Proposal of amendments to Inf. Doc. N° 3 (R 48) Presented by France

6.20.4.1.1 Figure :

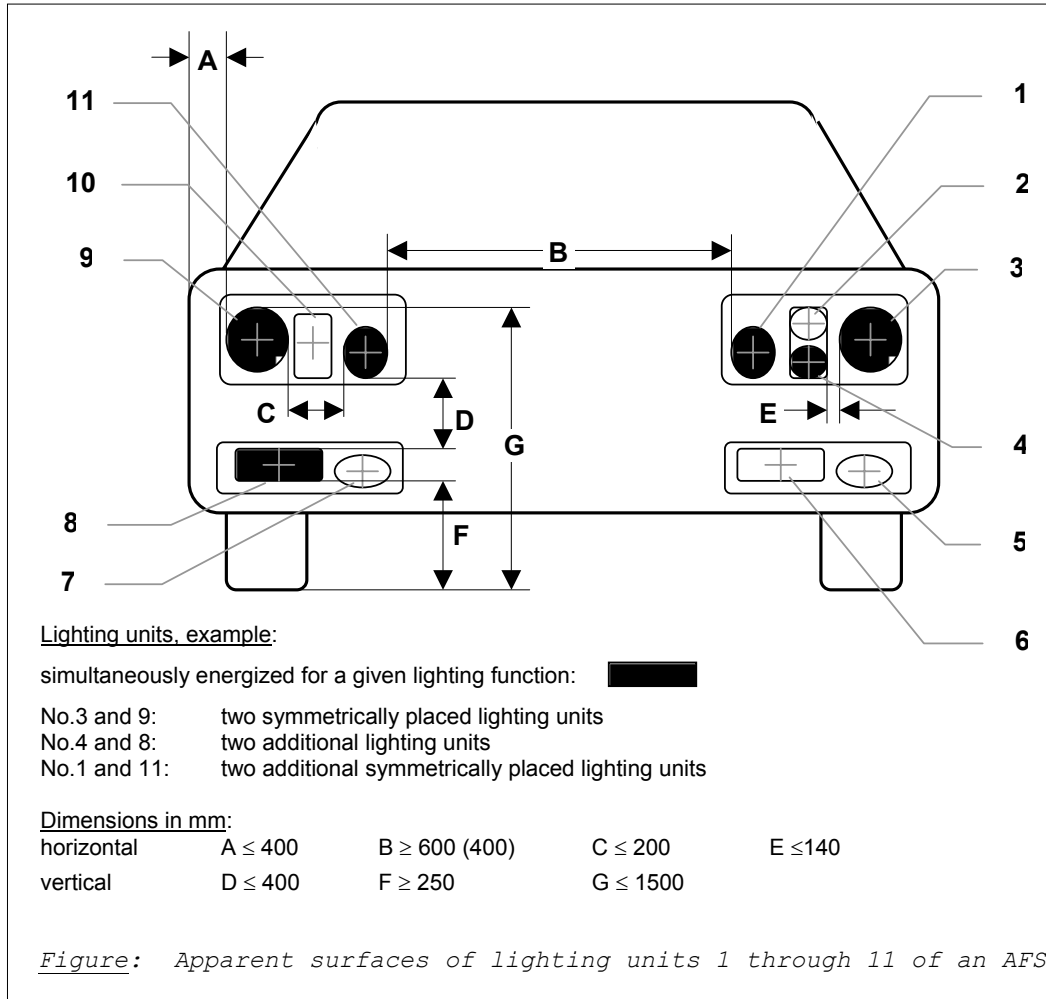
<u>Dimensions in mm:</u>			
horizontal	A ≤ 400	B ≥ 600 (400)	C ≤ 200	E ≤ 140 200
vertical	D ≤ 400	F ≥ 250	G ≤ 1500

6.20.4.1.2. Additional lighting units, if any, on either side of the vehicle shall be positioned at a distance not exceeding ~~440~~ 200 mm
~~7/ In case of additional "two symmetrically placed lighting units" the horizontal distance may be 200 mm (CC in the figure).~~
